Environmental Minor Project Refinement Form

Project Name: West of Devers Upgrade Project **Request Prepared By:** Sylvia Granados

Date Approval Required: 12/6/2019 **Variance Request No.:** 32

FIGURE 1
Page 6 of 13
Southern California Edison
West of Devers Upgrade Project
WSS-4-4X44-1-MPR-32
& GS-4-W-4X43-3-MPR-32
MPR #32

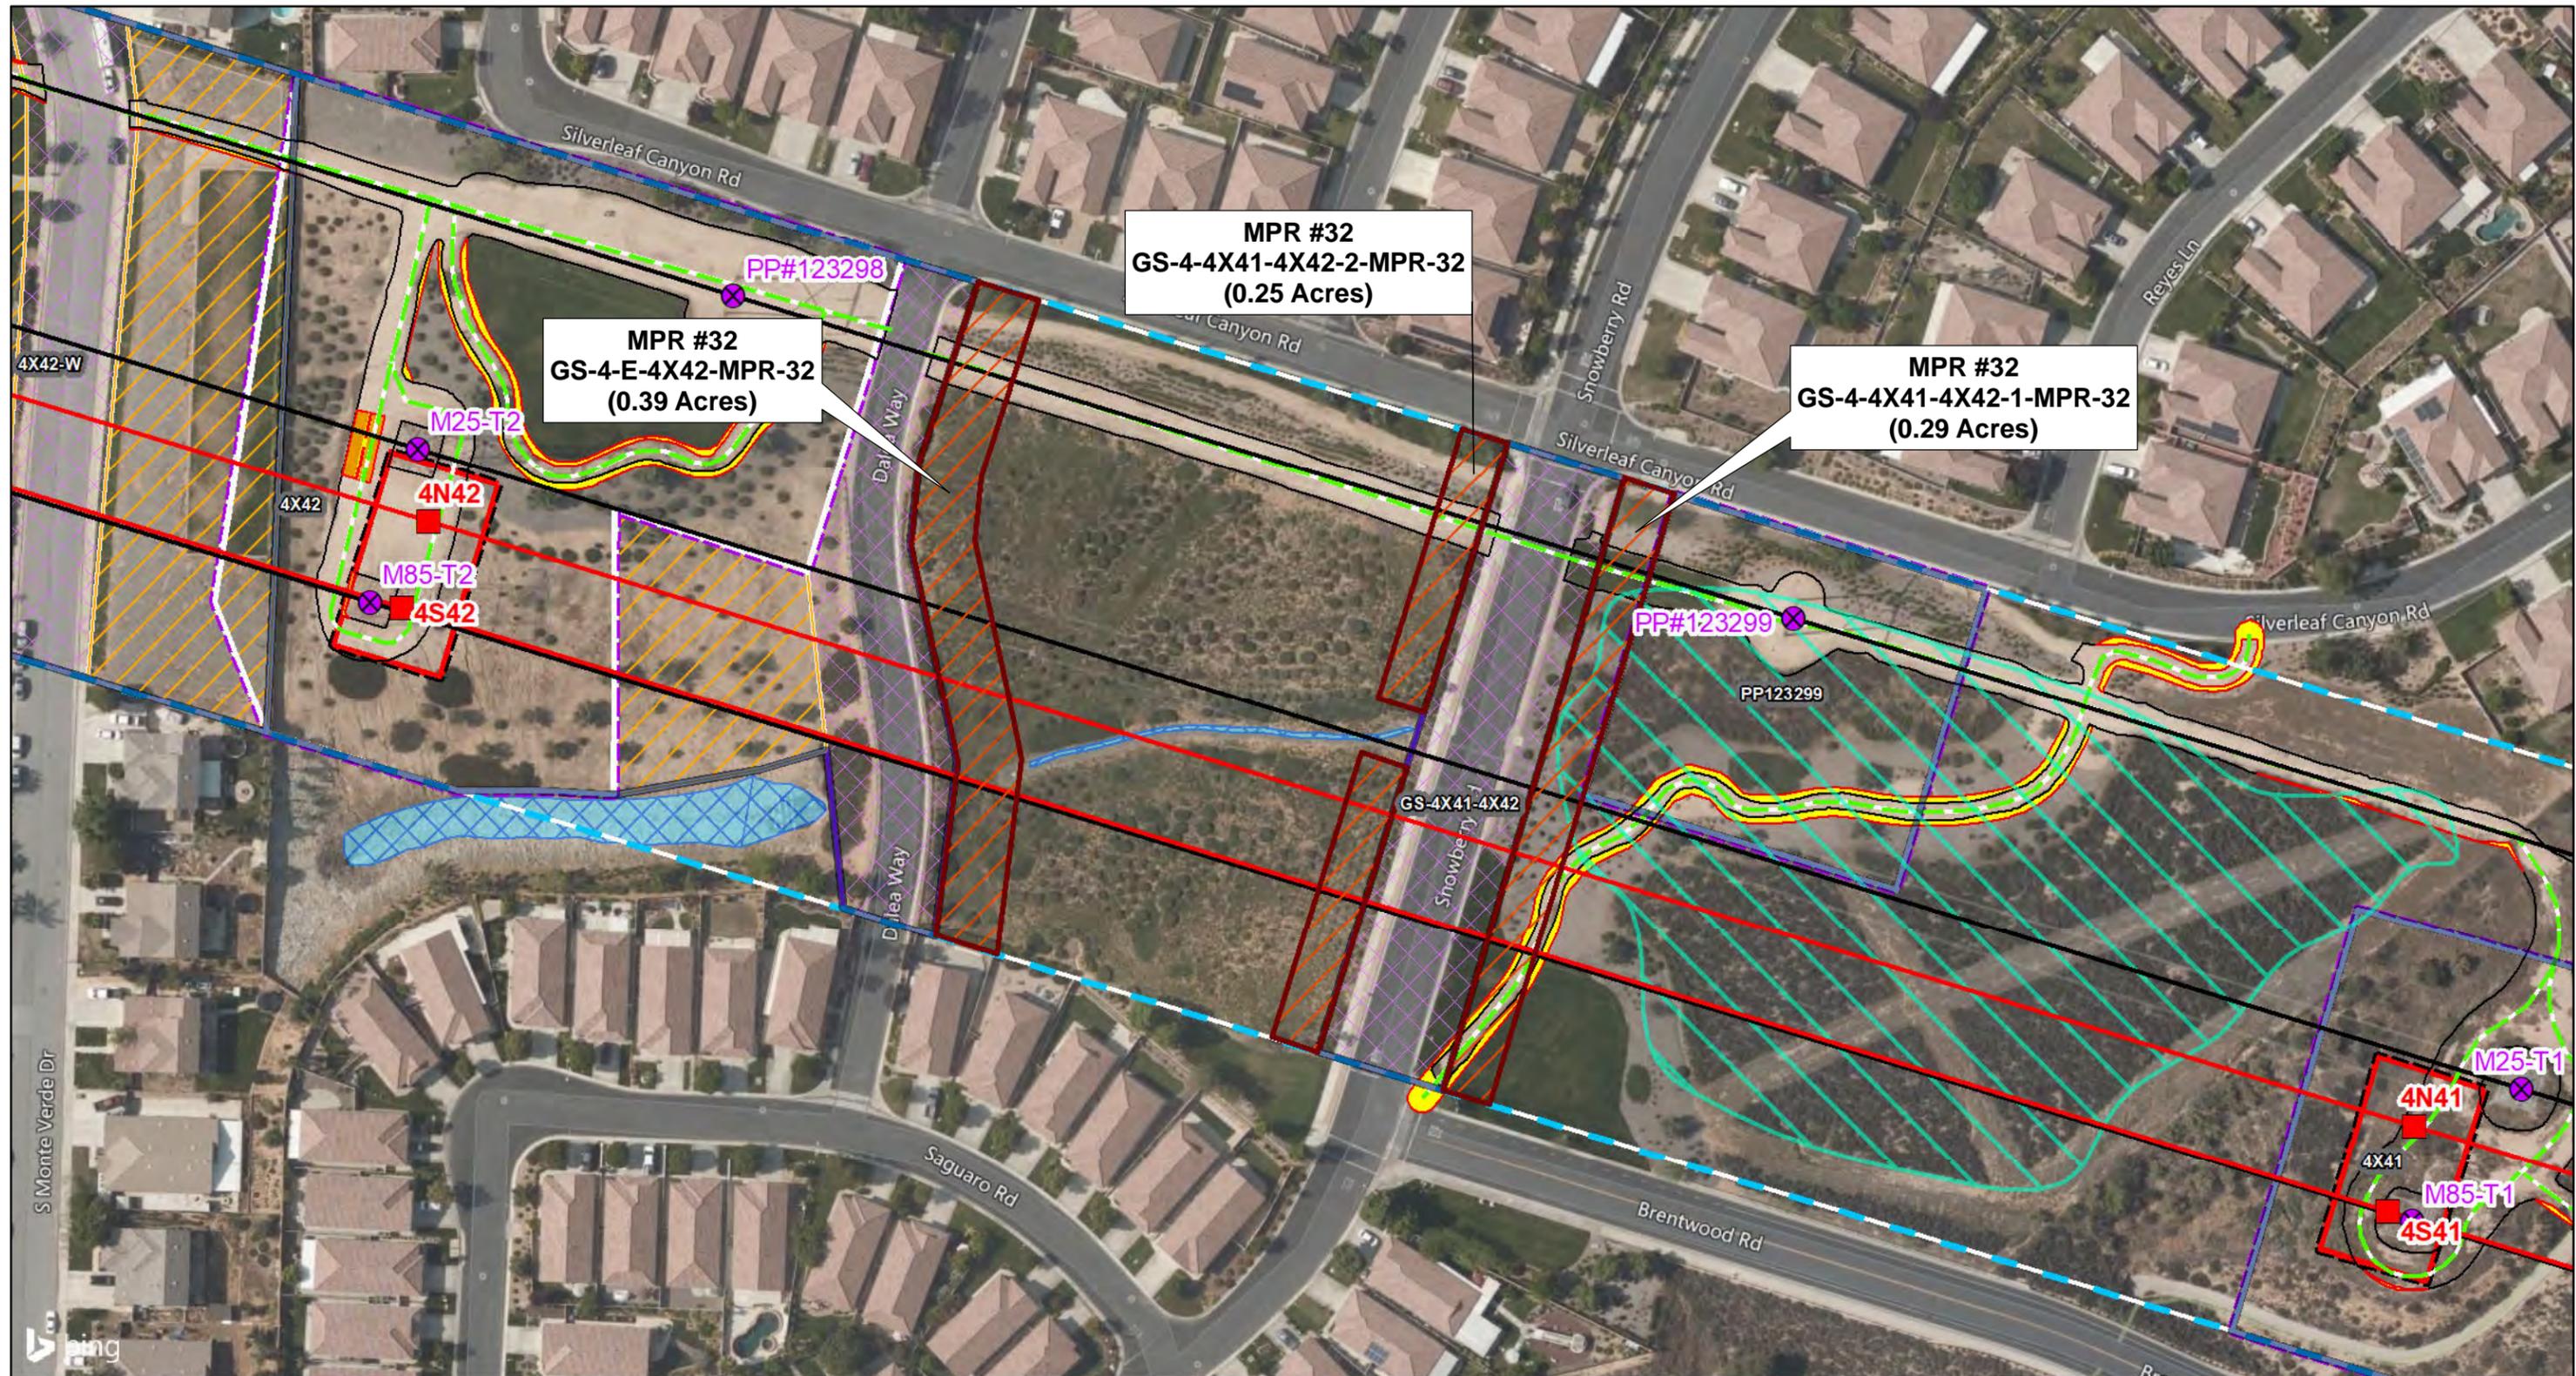
WSS-4-4X44-1-MPR-32, GS-4-W-4X43-3-MPR-32: Expansion of Supersites 4X44-1 and GP-4X43-W for Wire Stringing Activities at 4X43 and 4X44

Two new temporary work areas are required east of I-10 and Supersite 4X44-1 and west of Supersite GP-4X43-W to facilitate wire stringing activities associated with tower sites 4X43 and 4X44, as shown on Figure 1, Page 6. The new work areas will not require site preparation for use.

The total temporary disturbance space associated with the new work areas consists of approximately 2.94 acres of developed/disturbed land. One work area is privately owned and the other is owned by the City of Beaumont, and are located within the SCE transmission line right-of-way.

FIGURE 1
Page 9 of 13
Southern California Edison
West of Devers Upgrade Project
GS-4-4X29-4X30-MPR-32
& WSS-4-4X29-MPR-32
MPR #32

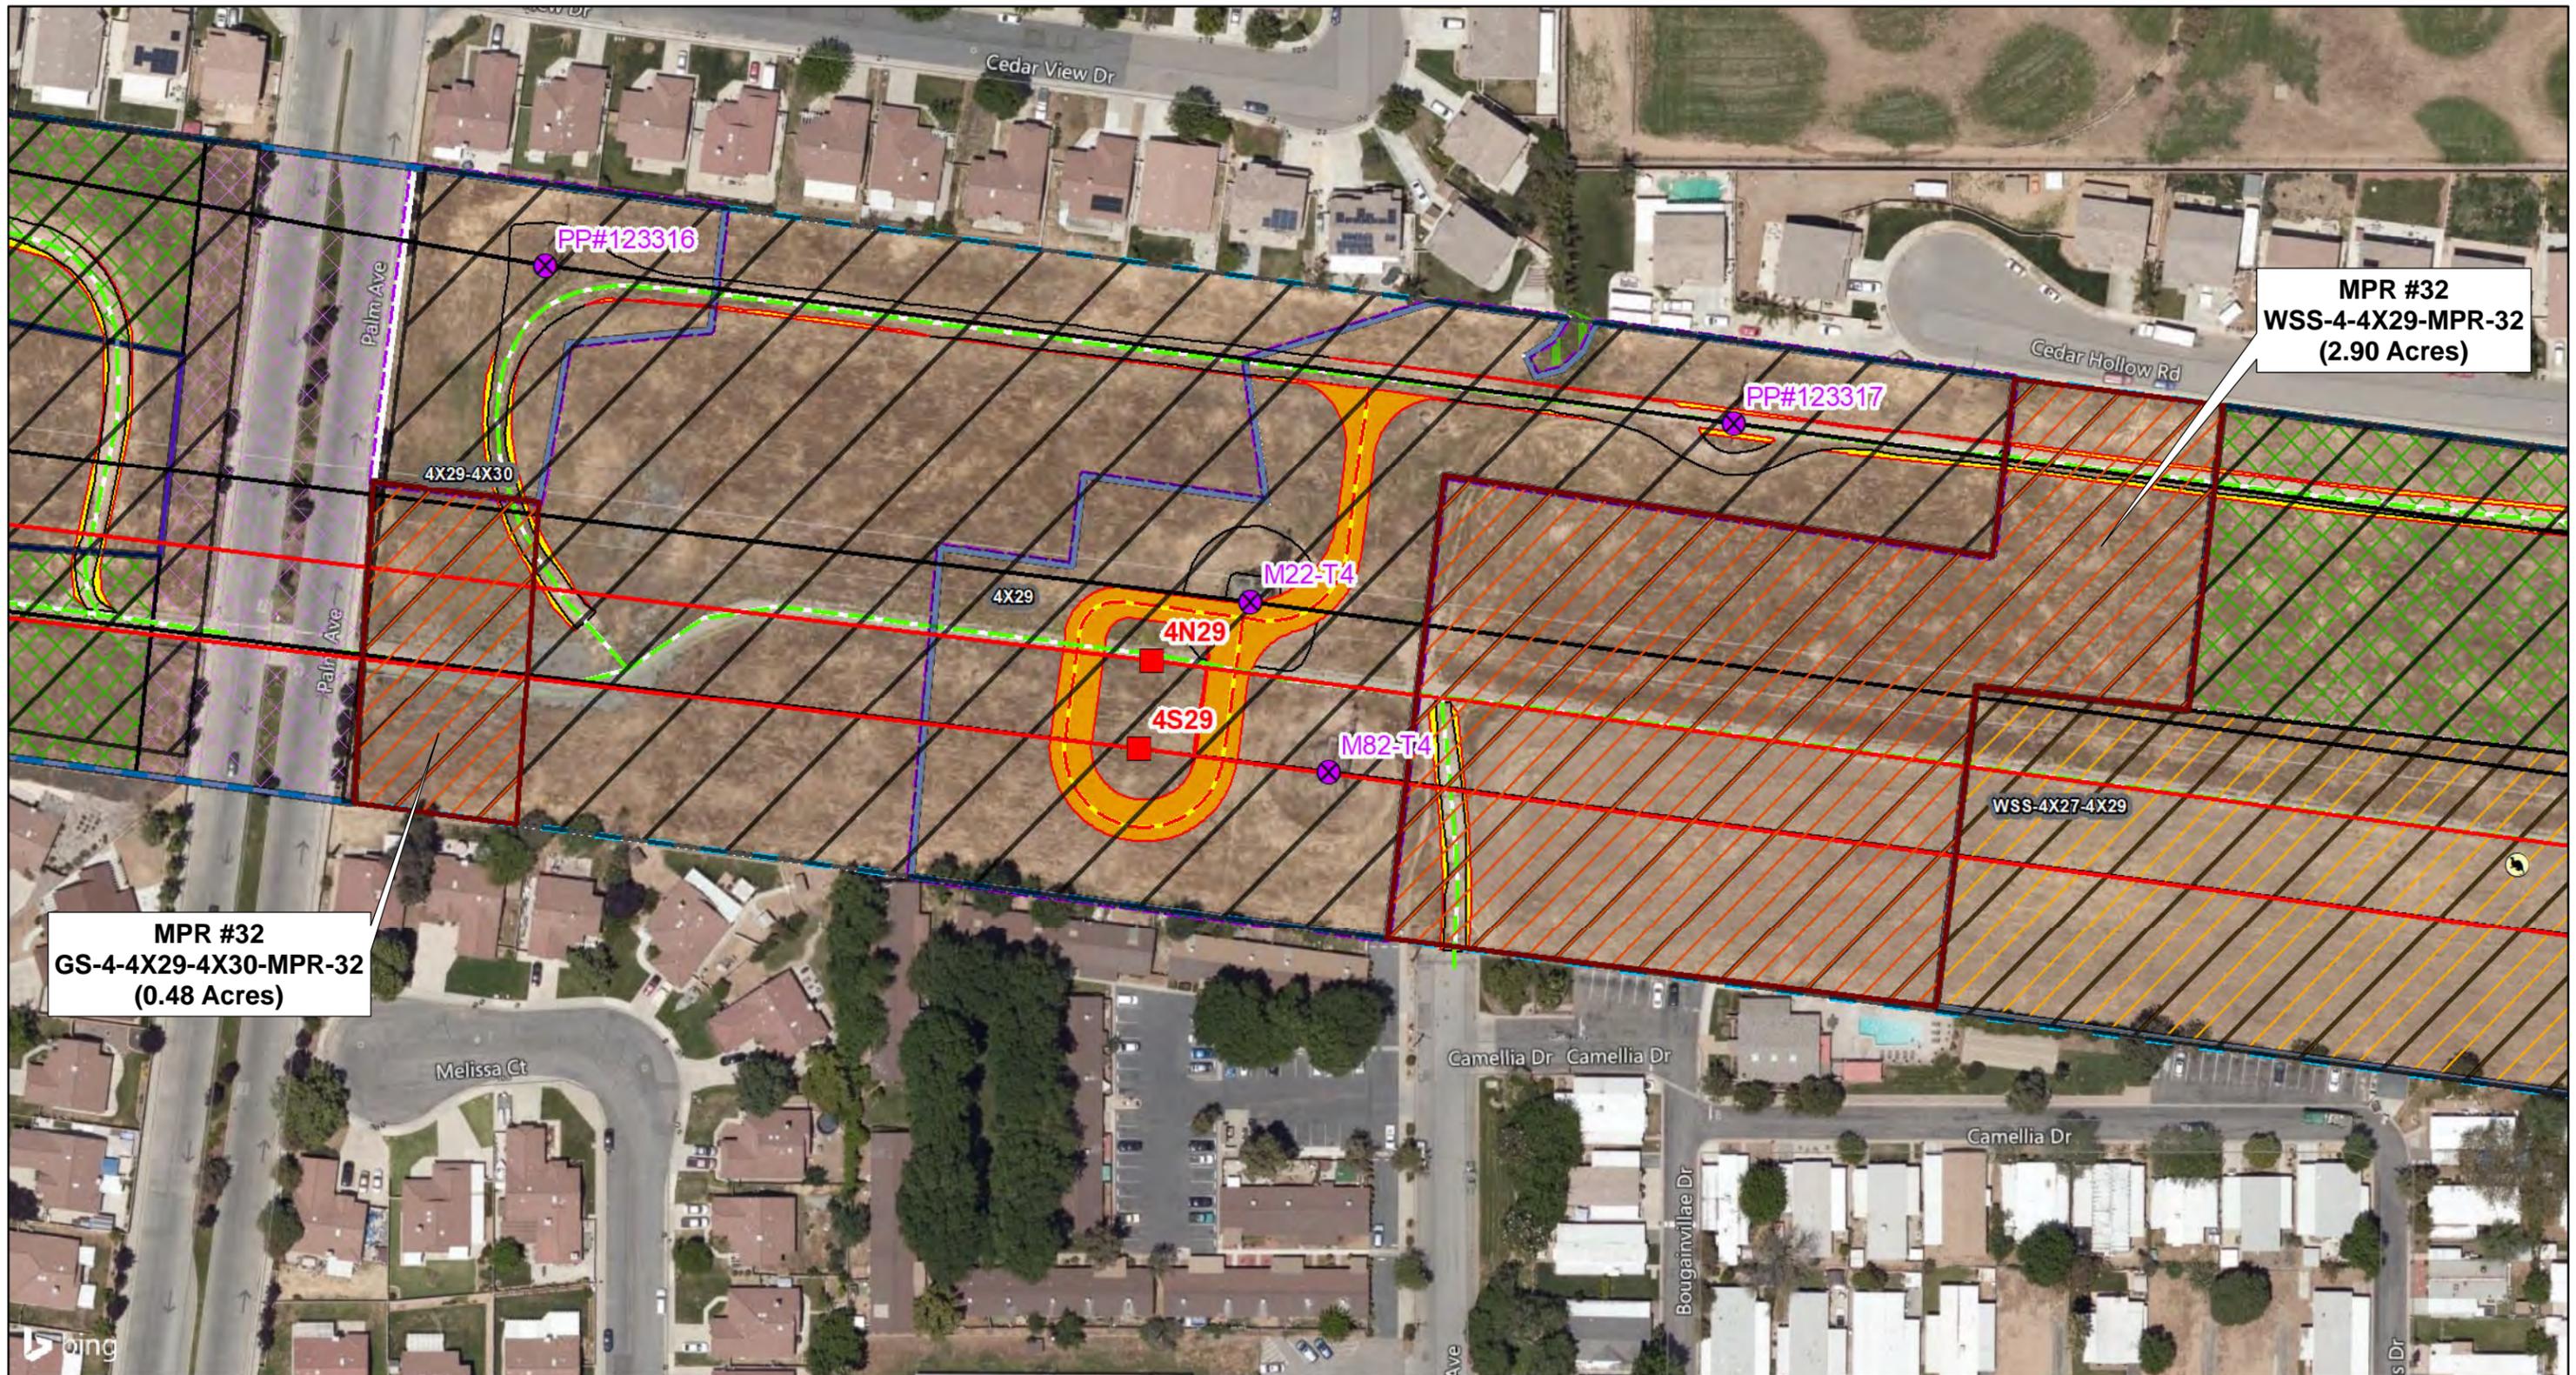
GS-4-4X29-4X30-MPR-32, WSS-4-4X29-MPR-32: Expansion of GS-4-4X29-4X30 and WSS-4X27-4X29

Two new temporary work areas are required east of GS-4-4X29-4X30 and west of WSS-4X27-4X29 to facilitate wire stringing and wreck-out activities associated with tower sites 4X27, 4X29, and 4X30, as shown on Figure 1, Page 9. The new work areas will require minimal site preparation for use.

The total temporary disturbance area associated with the new work areas consists of approximately 3.38 acres of developed/disturbed land (.43 acre) and grassland/forland (2.95 acres). The work areas are both privately and publicly owned by the City of Beaumont and located within the transmission line right-of-way.

FIGURE 1
Page 10 of 13

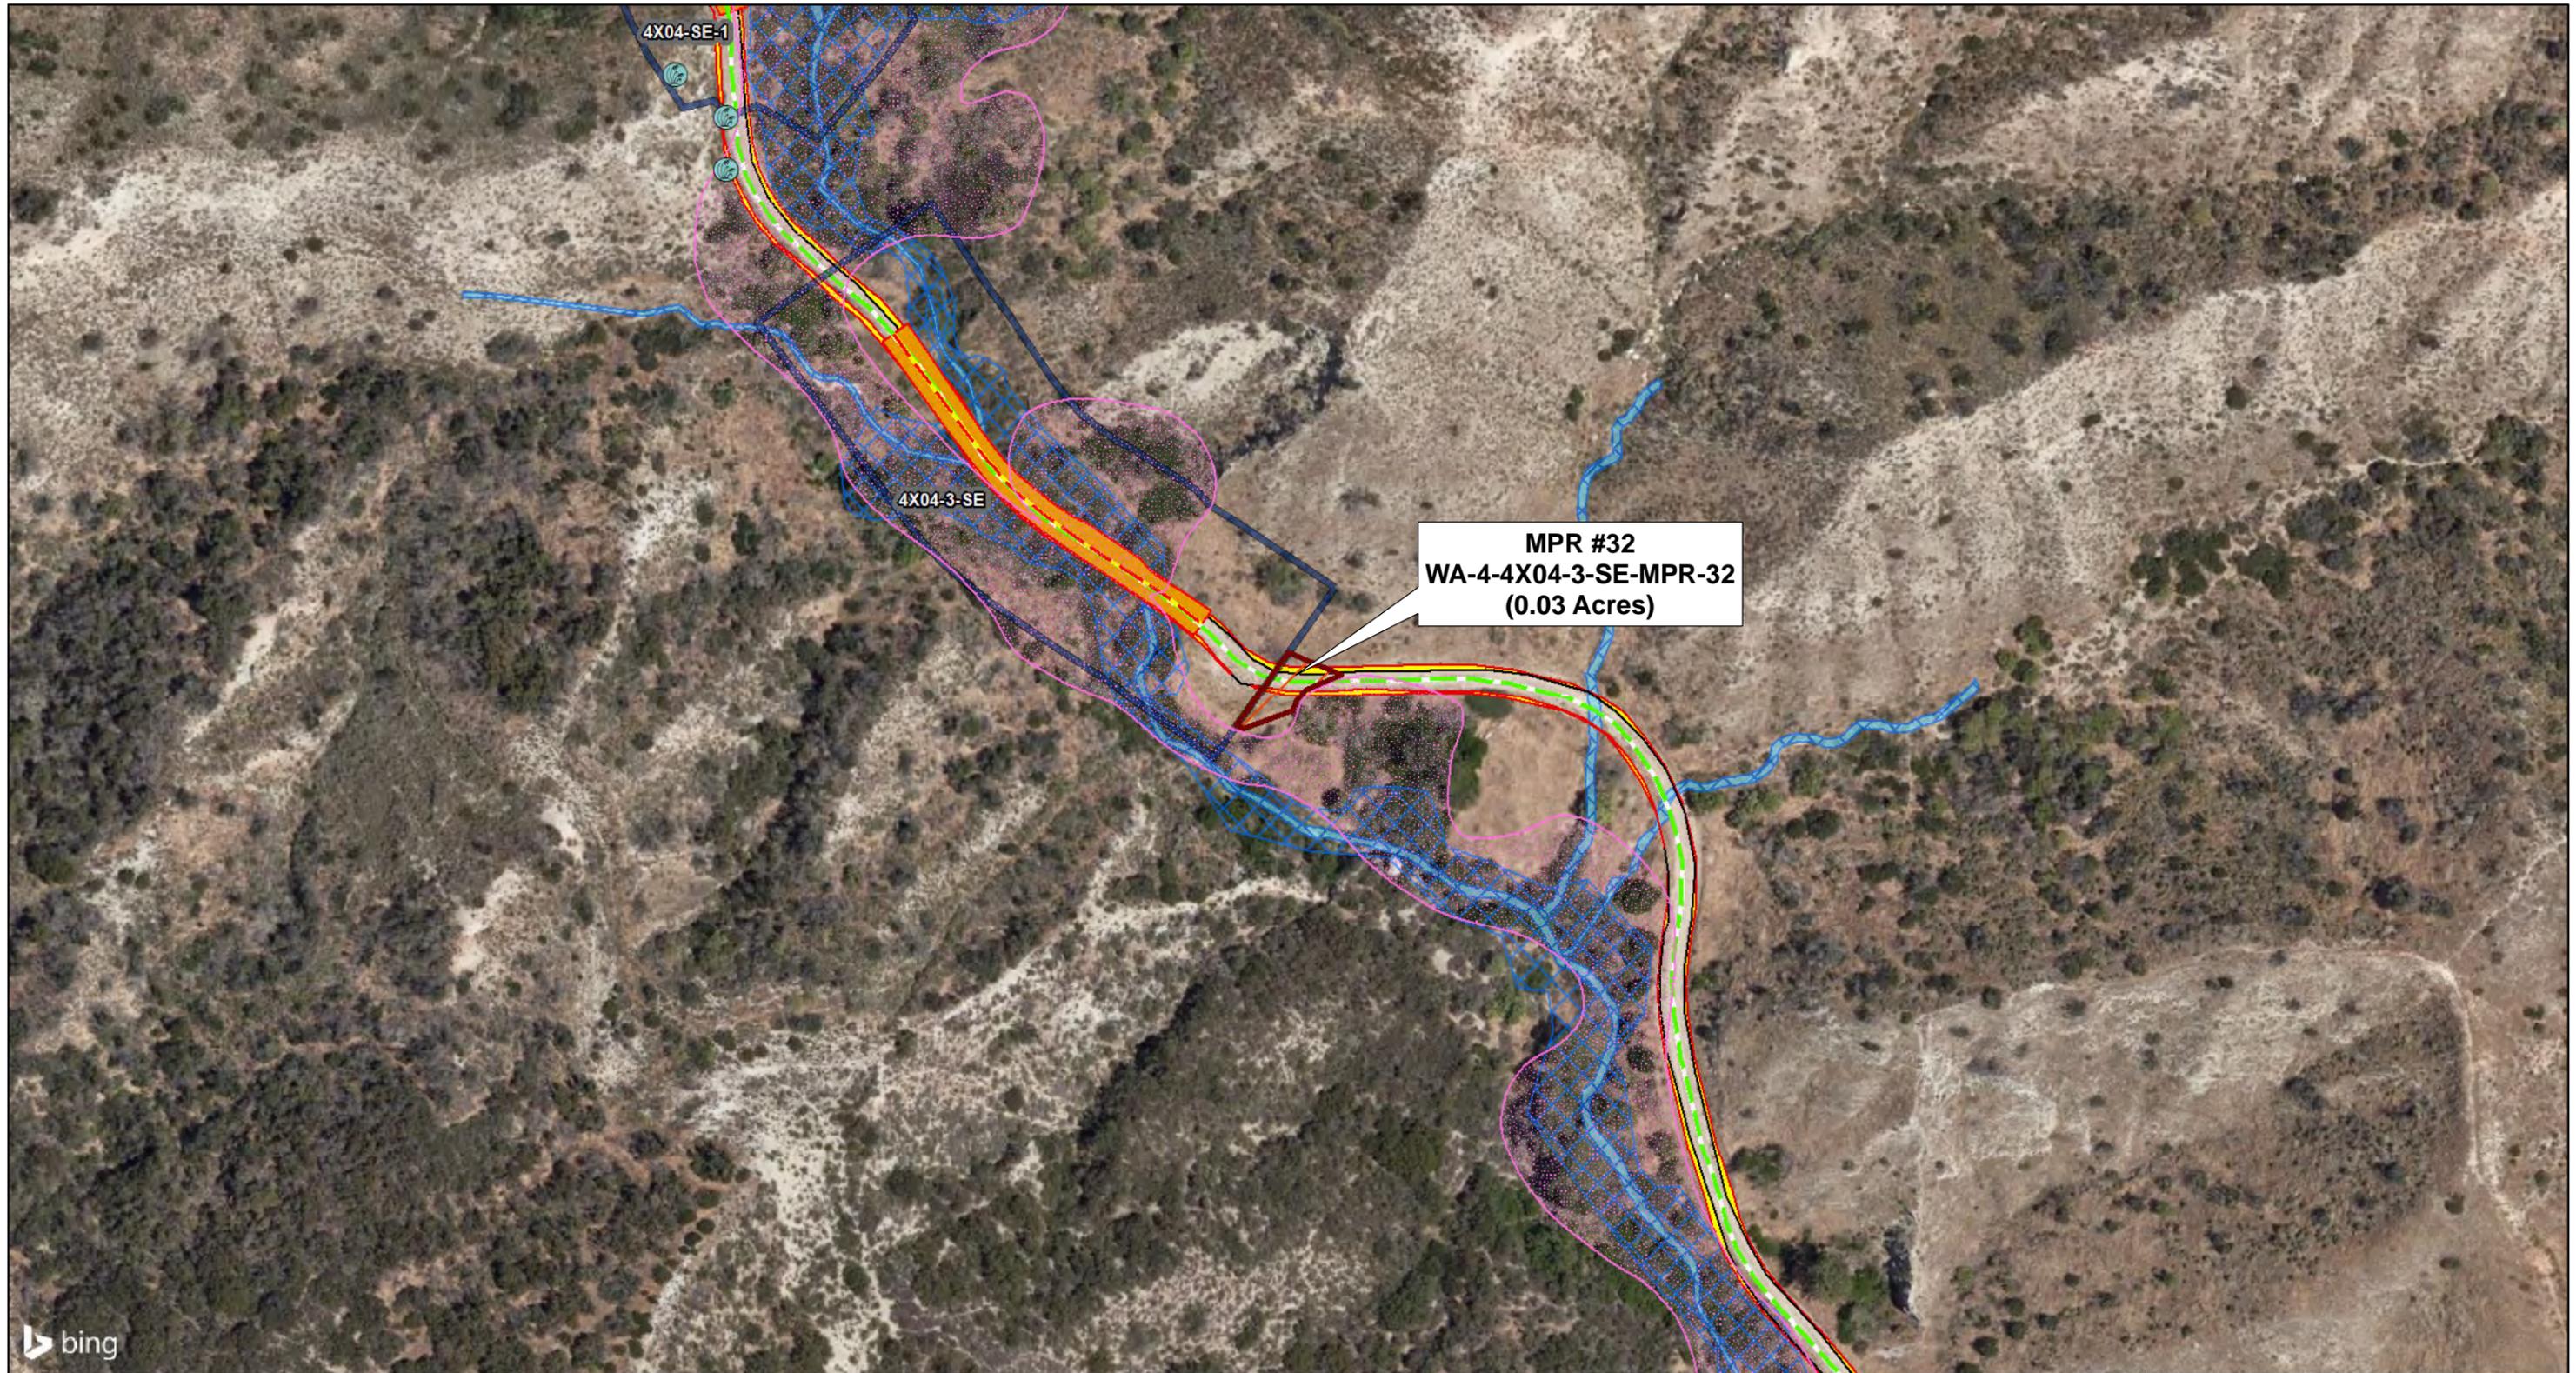
WS-6-CedarRd-MPR-32: Existing water source west of Mountain Avenue

Rubber tired water trucks will park on the shoulder of the existing/public road adjacent to the existing water source location (i.e., hydrant) shown on Figure 1, Page 10. Only occasional short-term filling of water trucks will occur, while allowing access to local land uses. No ground disturbance will occur at the water source location. No impacts to

The potable hydrant is supplied by the City of Banning Public Works Department and is located on the southwest corner of the intersection of Mountain Avenue and Cedar Drive (33°56'11.45"N , -116°55'14.57"W) in the City of Banning, as shown on Figure 1, Page 10.

The total temporary disturbance area associated with the new work area consists of approximately .02-acre of previously developed/disturbed land, owned by the City of Banning in the public ROW.
